Draft Value Engineering Study Report

TO: Mr. John C. Taylor, P.E. Value Engineering Coordinator Mississippi Department of Transportation 401 Northwest Street Jackson, Mississippi 39201	DATE: June 6, 2011 MACTEC PROJECT NO.: 6180-11-1028 PROJ. NAME: I-20 MS River Bridge to E of US 61N Interchange MDOT PROJ. No. IMD-0020-01(181) SUBJECT: DRAFT Value Engineering Report
--	--

VALUE ENGINEERING REPORT

I-20, From the Mississippi River Bridge
to East of the US 61N Interchange
Project No. IMD-0020-01(181)
Warren County, Mississippi
May 23–27, 2010

IDEA No.: A-12	Sheet No.: 1 of 4	CREATIVE IDEA: Eliminate 1-lane from the 5-lane On-ramp / CD lane merge – weave section in the west quadrant of the US 61N / I-20 Interchange.
--------------------------	-----------------------------	---

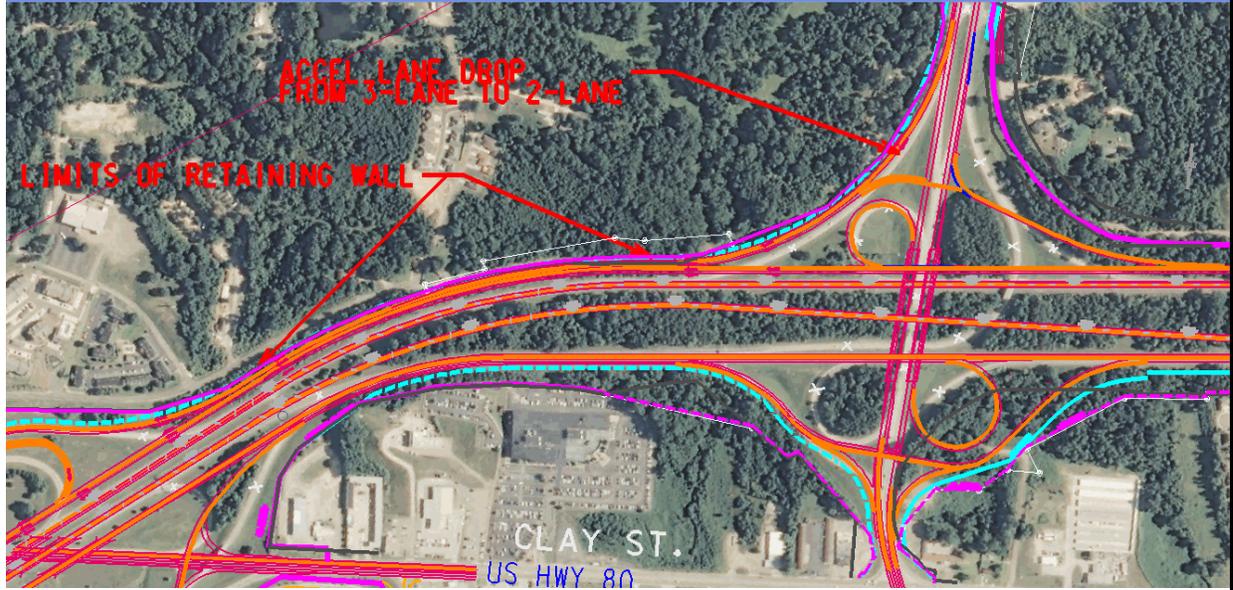
The current design includes a Northbound (NB) SR 27 / US 61N to Westbound (WB) I-20 on-ramp on the north side of the US 61N / I-20 Interchange. The on-ramp is in the NW quadrant of the Interchange. This on-ramp combines with the 2-lane Southbound (SB) US 61N to Westbound (WB) I-20 on-ramp as an additional lane. The 3-lane SB US 61N to WB I-20 on-ramp combines with the 2-lane WB I-20CD lanes to form a 5-lane weaving section on the north side of the Interstate (Approximately Station 250+00 to Station 270+00).

This recommendation creates an acceleration lane by tapering the inside lane of the 3-lane SB US 61N to WB I-20 on-ramp downstream of the median crossover approaching the 2-lane WB I-20 CD lanes. This concept results in a 4-lane weaving section (Approximately Station 250+00 to Station 270+00).

The low volume of NB SR 27 to WB I-20 traffic that would use the median crossover on-ramp and merge with the SB US 61N to WM I-20 lanes can easily be accommodated before getting to the 4-lane weaving section. The on-ramp merge (lane drop) removes one lane from the complex north side merge / weaving area and therefore simplifies the weaving movements while reducing the amount of required retaining wall adjacent to the ROW within the same weaving area limits. This concept improves traffic operation and saves costs.

Idea No.: C-2
Client: MDOT
Sheet 2 of 4

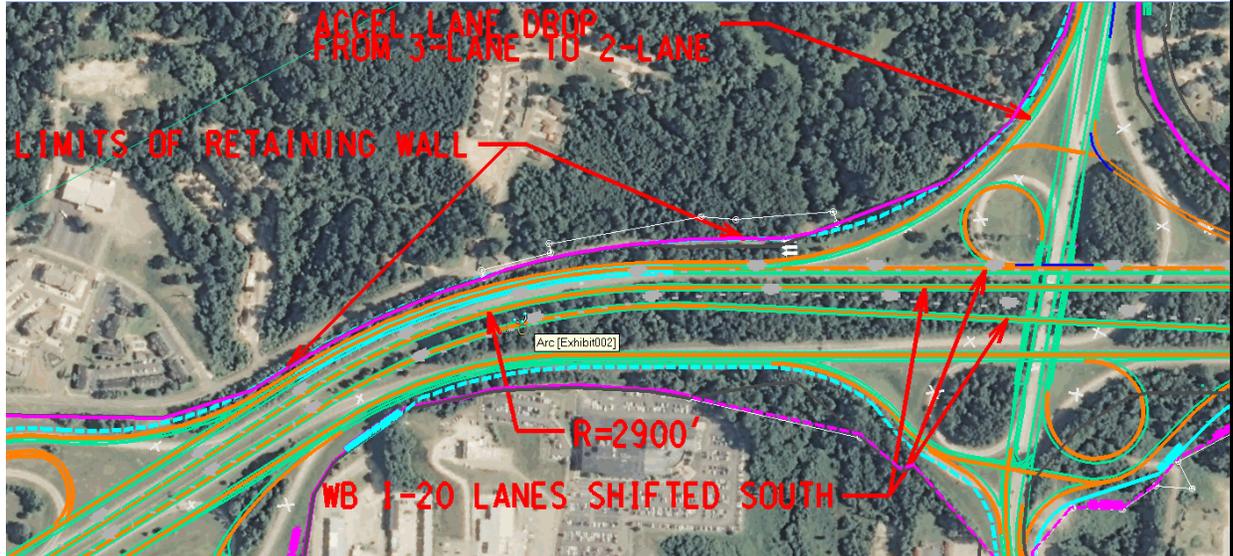
Original Concept: The current design keeps the reconstructed I-20 WB lanes between US 61N and Clay Street on the existing WB I-20 alignment and would construct the new CD / on-ramp merge lanes to the outside (north) of these lanes. This concept requires the WB I-20 to SB SR 27 Loop off-ramp and the SB US 61N to WB I-20 on-ramp to be shifted away (north) from the existing facility. This shift requires additional R/W and the construction of a large retaining walls in steep terrain.

This recommendation would shift the WB I-20 mainline roadway to the inside (south) of the existing WB I-20 footprint to a new alignment in the existing median, and allow the new SB on-ramp / WB CD lanes to follow the existing WB I-20 ramp and mainline footprint.

Justification: By shifting the WB I-20 lanes and CD / on-ramp lanes south, the requirement for extensive excavation in the US 61N / I-20 WB Quadrant requiring retaining walls will be greatly reduced. This idea also shortens the new US 61N / US 27 Bridges over I-20. Constructing the new CD lanes on the old WB I-20 mainline roadway footprint allows the WB I-20 to SB SR 27 Loop off-ramp and the SB US 61N to WB I-20 on-ramp to be reconstructed on their existing alignment. The shift in the I-20 mainline roadway would maintain the required 88-foot Type I Access median width to allow for future widening to the inside. These shifts can be accomplished with changing the current CD lane design configuration.

Idea No.: G-5
Client: MDOT
Sheet 2 of 4

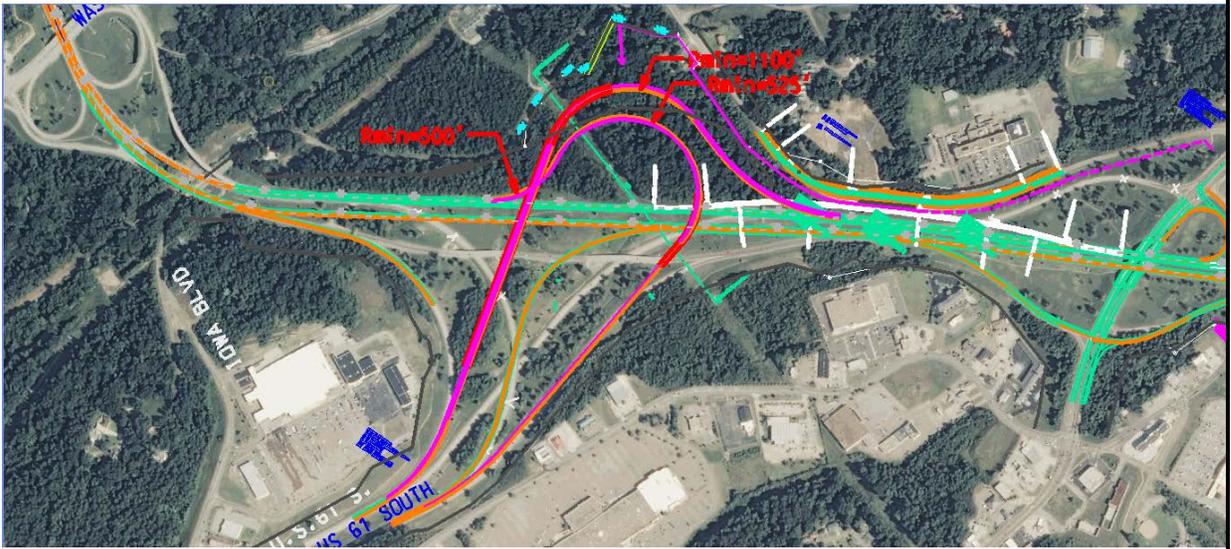
Original Concept: The current design to revise the I-20 / US 61S directional Interchange on the west end of the project would construct a Trumpet Interchange between Station 50 and Station 80. This concept eliminates the existing “left” on and off ramps. The current Trumpet design requires new R/W on the north side of I-20, comes very close to the Military Park property, and contains long ramps with long flyover bridges.

Proposed Change: This recommendation would reverse the curve for the NB US 61 to WB I-20 on-ramp. This concept also tightens the WB I-20 to SB US 61S off-ramp around the outside of the new reversed curve on-ramp.

Justification: The VE design provides right on / off connectivity. This concept keeps the south end of the new on-ramp on the existing NB US 61S on-ramp alignment longer and reverses the ramp curve to turn left and connect to WB I-20 near Station 55. The revised design reduces the length on the on-ramp and flyover bridge section of the ramp. It reduces the amount cut on the north side of I-20 and better follows the existing terrain as it connects to I-20. This concept put the WB on-ramp connection on a down grade improving merging.

The SB off-ramp is also shifted inward toward the revised WB on-ramp. This brings the ramp closer to the hill on the north side of I-20 thereby reducing the length of the flyover bridge. The ramp shifts reduce R/W needs, reduce impacts to the Military Park, and reduce project cost.

Idea No.: I-1
 Client: MDOT
 Sheet 2 of 4

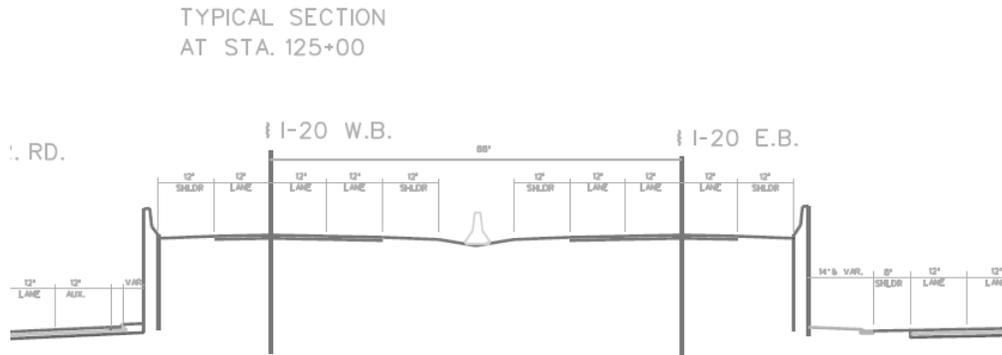
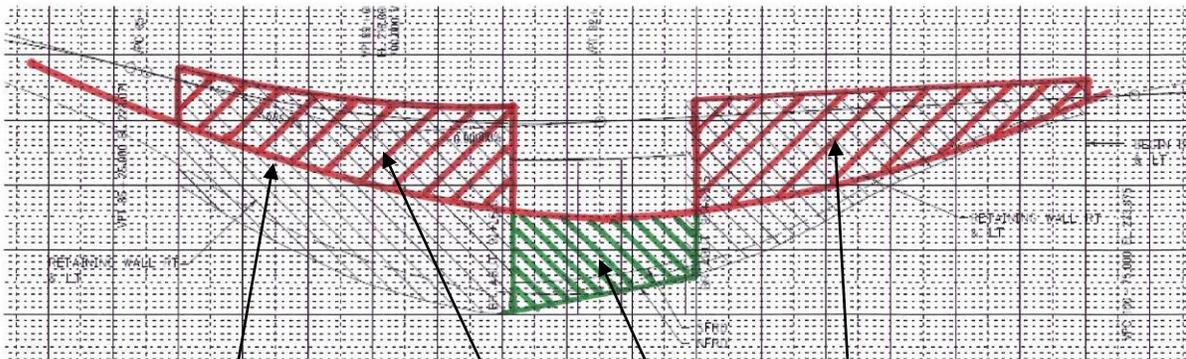
Proposed Change: This recommendation would eliminate the Frontage Road crossovers allowing Frontage Road connectivity only at the Interchange cross streets.

Likely profile change without crossovers.

Additional Walls

Wall Reduction due to profile change.

Idea No.: R-2
Client: MDOT
Sheet 2 of 4

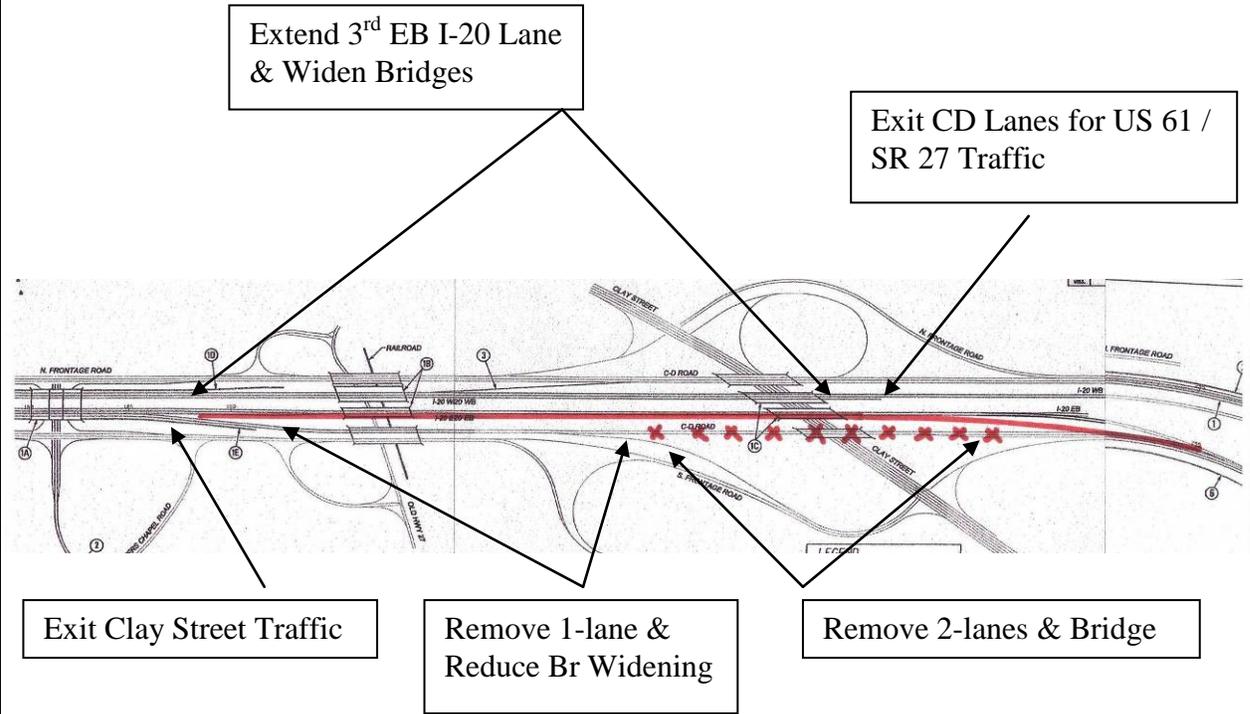
Proposed Change: This recommendation would split the EB CD off-ramp configuration. This concept would split the CD off-ramp traffic allowing only Clay Street traffic to exit I-20 at the original location (east of the FR crossover at Station 200) while keeping NB US 61N / SB SR 27 traffic on the mainline roadway to a new “second” exit starting just east of the I-20 bridge over Clay Street. This concept substantially shortens the CD road.

Justification: Providing separate off-ramps would simplify roadway signage, provide a more “standard” exit ramp configuration for the motorists, and eliminate merging Clay Street traffic with the CD lanes which primarily serve the NB US 61N / SB SR 27 exiting traffic.
